crane cove park master plan

BCDC DRB + WDAC presentation

september 09, 2013

summary of BCDC DRB + WDAC comments

master plan design alternative 1

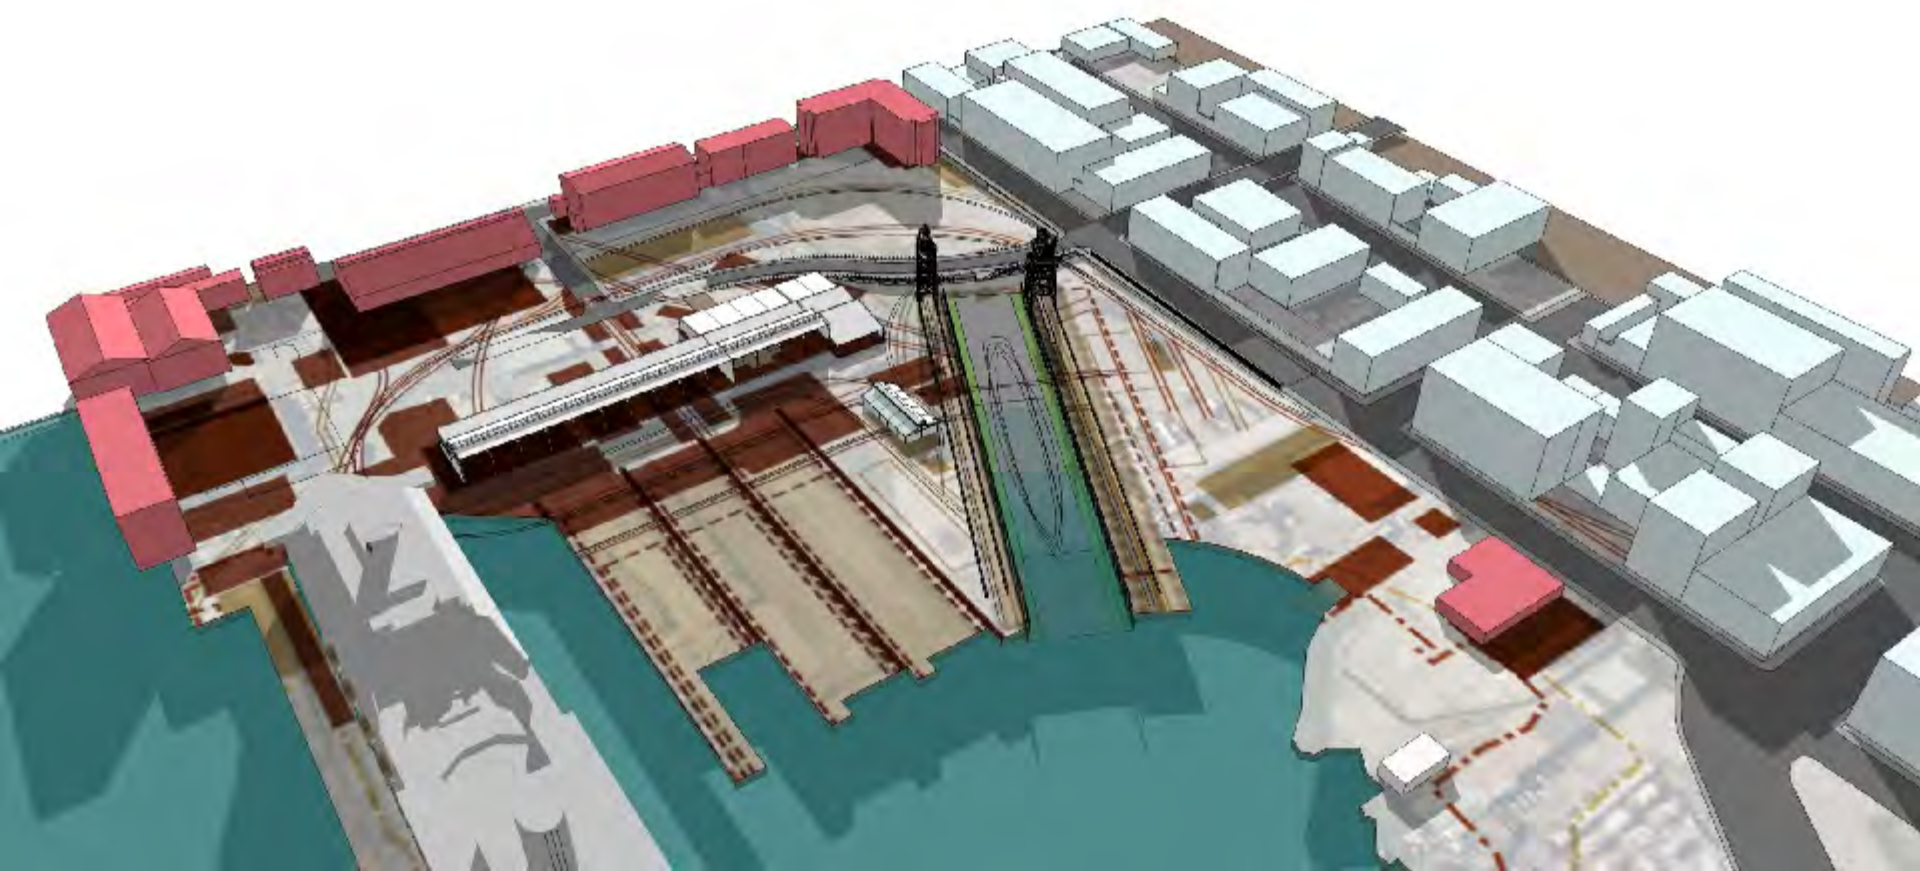
Two alternative design options were presented for Crane Cove Park, including Alternative 1, "Lines and Existing Traces," and Alternative 2, "Patches and Historic Uses." Alternative 1 would provide indirect public access to the park from an elevated pedestrian ramp off 19th and Illinois streets or by passing through Building 109. Alternative 2 would cover a portion of the slipway with fill to negotiate the grade difference between Illinois Street and the park, thereby enabling direct public access

part of the design process as well as the project team's commitment to reflect the historical significance of Pier 70. The committee prefers the interpretive approach of the "Lines and Existing Traces" scheme, which focuses on the World War II era, because of its simplicity. The interpretation in "Patches and Historic Uses," which seeks to convey multiple historical eras, appears overly-ambitious and somewhat abstract. We are concerned that this multi-layered approach would be confusing to the average park user.

What are your FAVORITE elements of the PARK master plan?

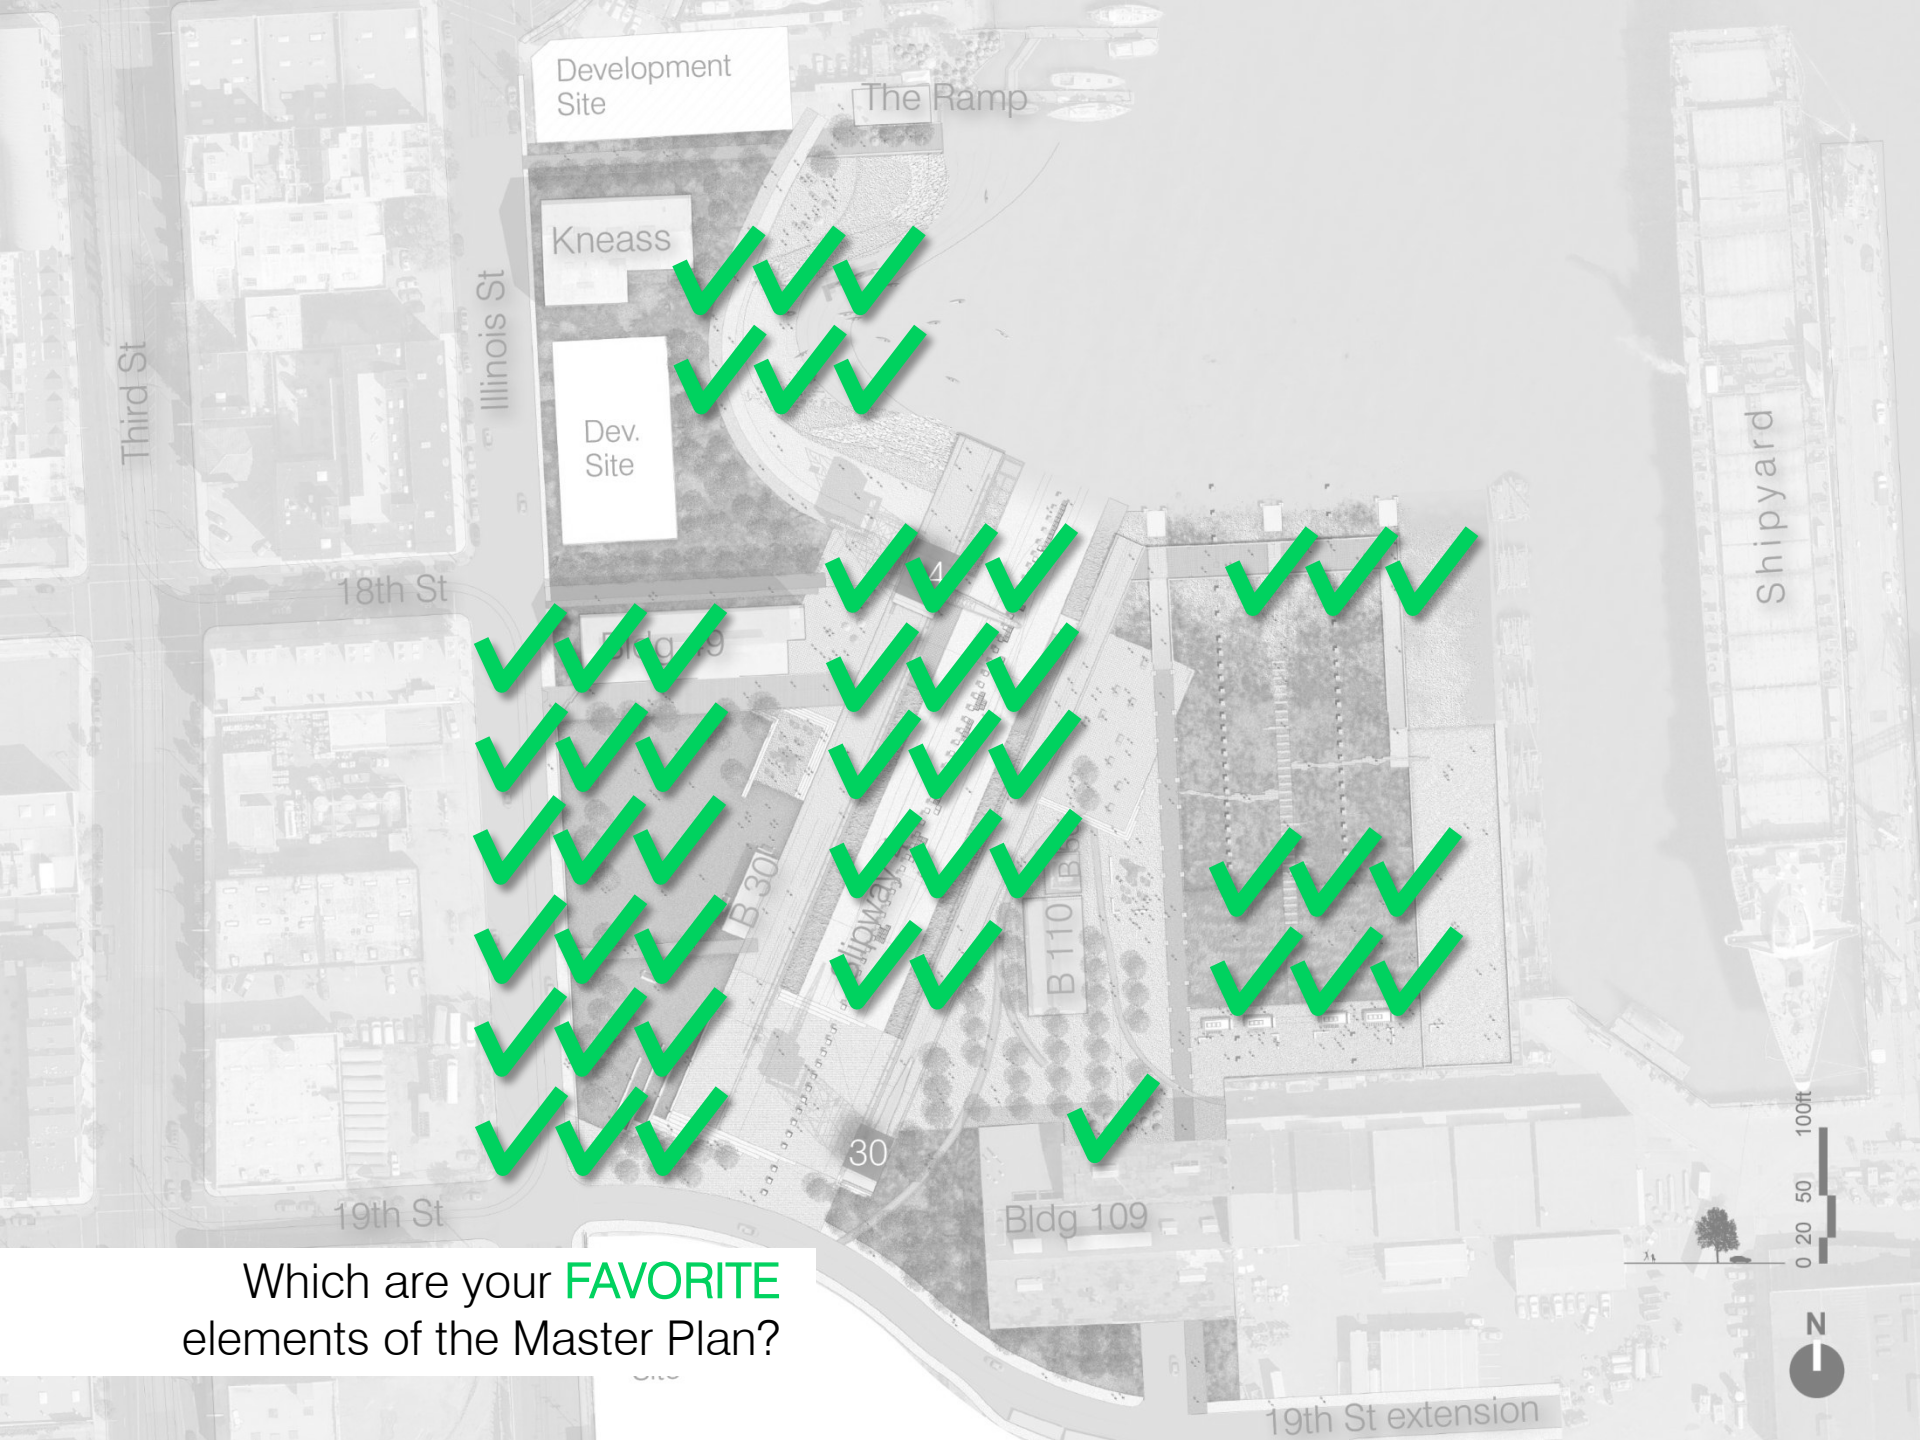
Open green spaces, views of water, incorporation of ship elements Open space, playground
Historic tracery and reuse - Tripartite Port Park concept (New, Historic, Working) The boat
launch / beach, the overlook, native plantings at Maritime Fields and the open green along
Illinois St. are my favorite programs. I also think the incorporation of the historic elements
especially the cranes will give the Park a special sense of place. Although it is a missed
opportunity that the public will not be able to access either of the cranes for viewing and/or
recreation. Really appreciate maintaining the exo-structure of the weighs at Slipway 4, along
with bldg 109. Also like the human-powered boat launch. Like the way the uses/plan honors the
adjacent neighbors (Ramp and boatyard). And, of course, saving the cranes. Like that there may
be a dog runway apart form grassy area for humans. Cafe and restaurant and sllipway on Pier

70- Water access point for human powered boats - something that is missing in SF
waterfront. Great open space - more than any other in Mission Bay Preserving the cranes and
slip incorporation Historic cranes, dog park, keel park historic element, "watercraft" launch,
trend line from wild native plants to manicured. Slipway 4 Slipway 4, waterfront edge,
slipway 3-4 (bridge), Bike lane I love the cranes as a companion to the industrial uses. Love
the green open area and slipway 4/crane rehab. The bosque area with Building 109 is also
beautiful. 1) Bay access to the park 2) Boat (human powered) loading 3) Either pier or beach
to launch from 4) Storage for human powered boats 5) Preserving historical periods of park 6)
Open Spaces for people to picnic, enjoy 7) Storage, YAY! Beach/boat launch, open green

What are your LEAST FAVORITE elements of the PARK master plan?

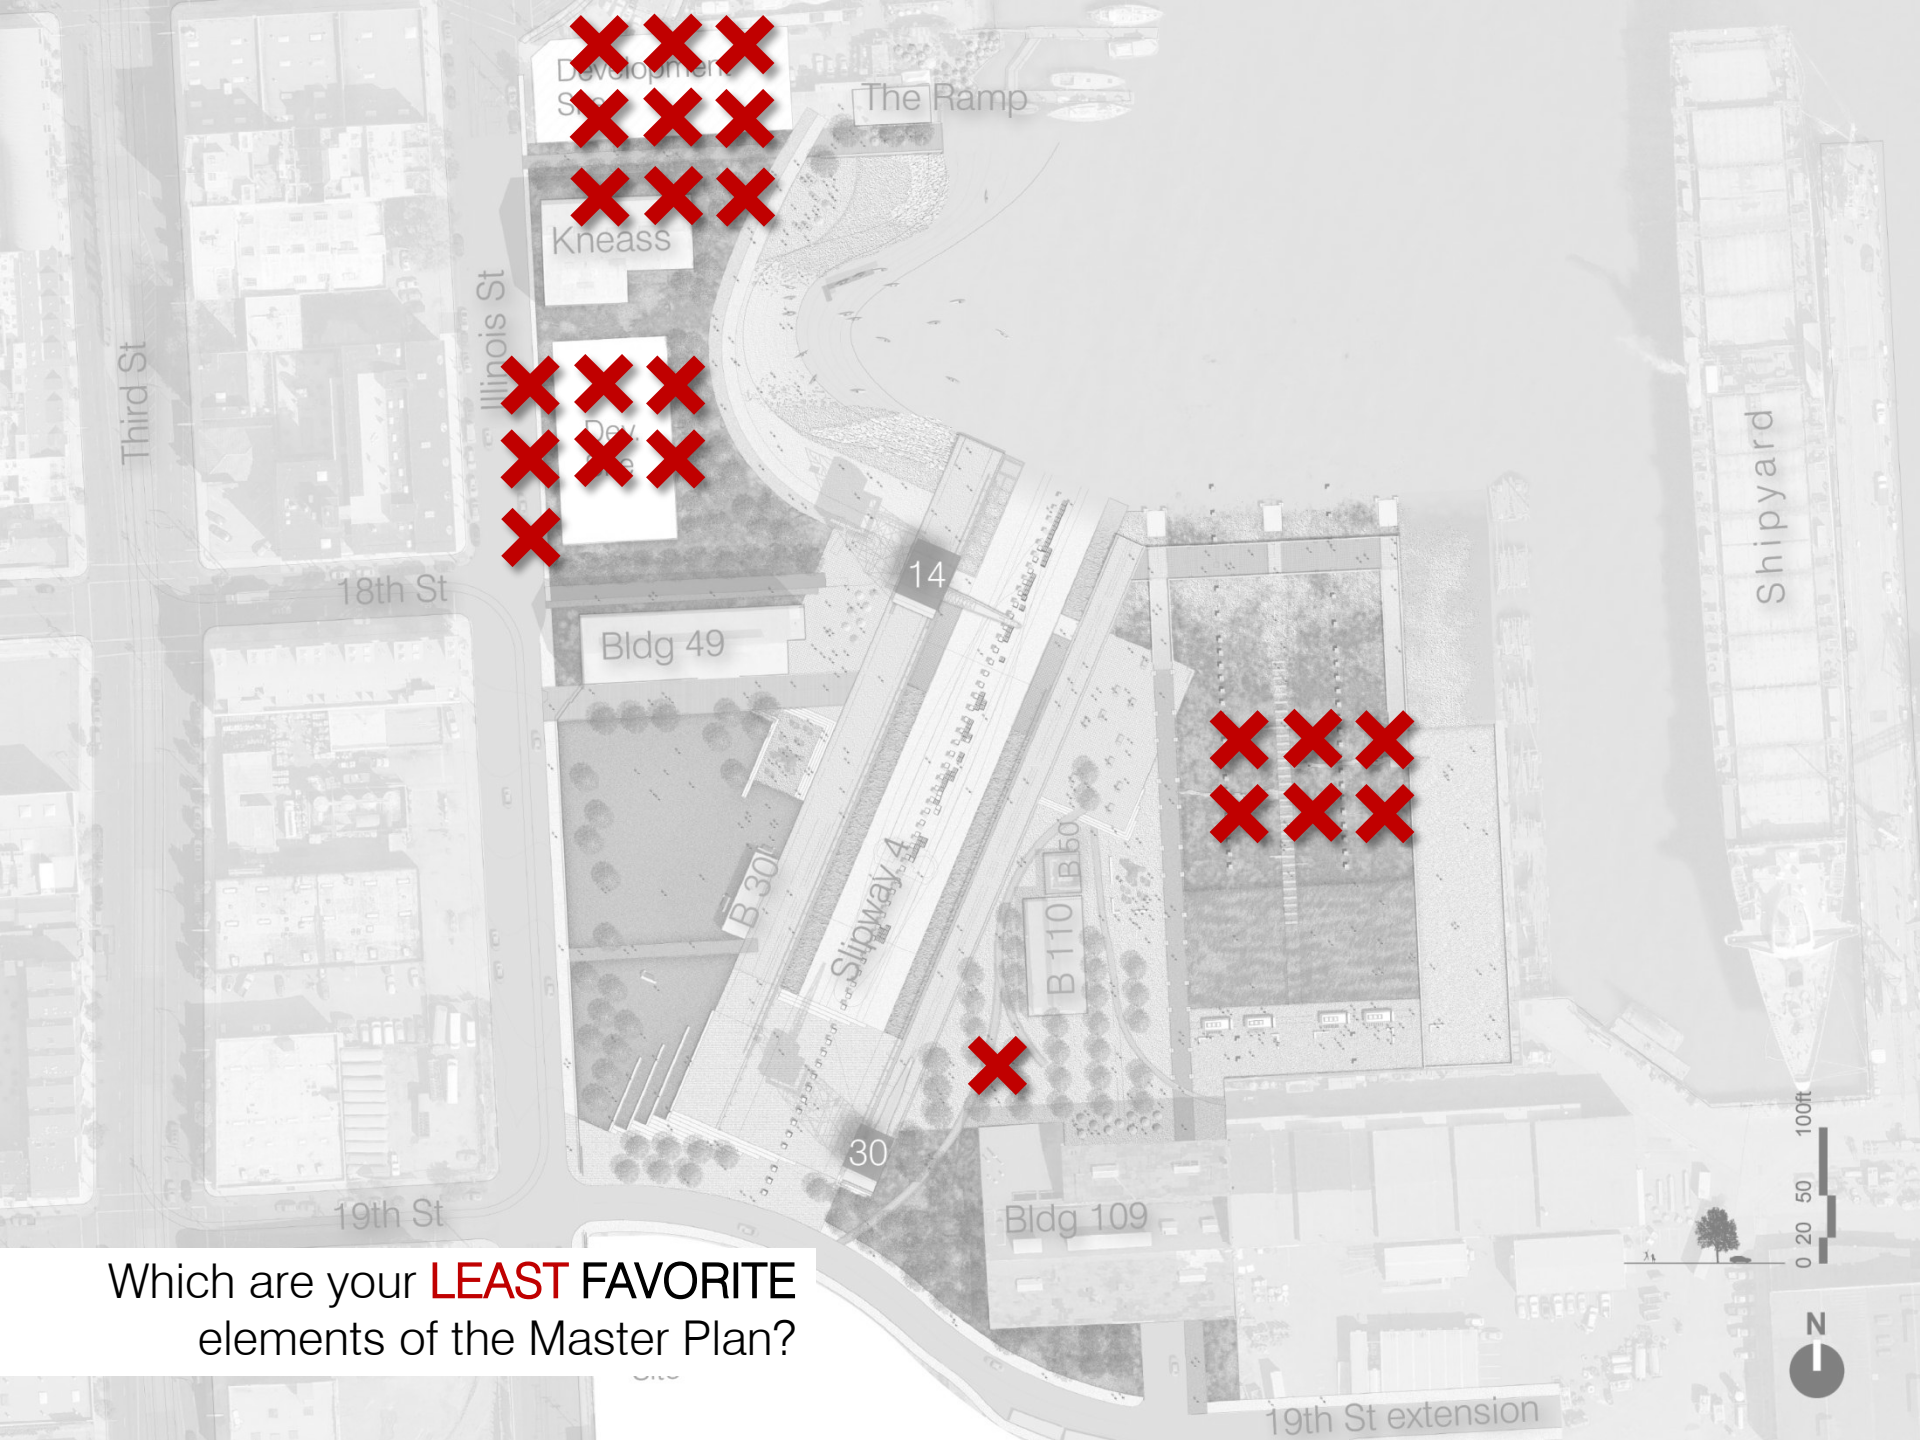
I personally am less excited about the human-powered boat launch infrastructure. I know everyone loves lawn but I think it is dull. Lawn feels less Pier 70. Not so sure about the tree/gravel area around bldg 110. The tree grid itself is fine, I'm just not sure I understand how this section will be used. I don't NOT like it, just haven't assimilated it--yet. Developments in front of the ramp? Besides the incorporation of porous surface materials to allow for integration, it isn't clear how the Master Plan incorporates a sustainable water strategy. Is there a plan to reuse stormwater for irrigation? Perhaps this is just due to graphics, but the pedestrian circulation structure lacks a clear hierarchy. Hard to tell what the primary, secondary, etc. moves are. The Blue Greenway route through the Park should read stronger. If one of the walks along Slipways 2 or 3 extended out to become a pier over the water it would create a more interesting / unique place, while also engaging with the dynamic movements of the Bay water coming into and out of the site. Can any of the exposed foundations north of the Wharf be made accessible? No real problems - Good Job! Slipway 2/3 The primary design moves are interesting. It is unclear, at this point, how this site will evolve over time, vis-a-vis the planting strategy. The depictions shown suggest a dense naturalistic landscape. Does the Port have the capability of maintaining this? Development site on Illinois between 18th and Mariposa. Being a little safe with public "entertainment" Restrooms in Phase 1 I am worried that there is not enough access to the water Cost of Phase 2 Need bathrooms. Agree with Toby - add some uniqueness/quirkiness. Concerned about development site heights of buildings
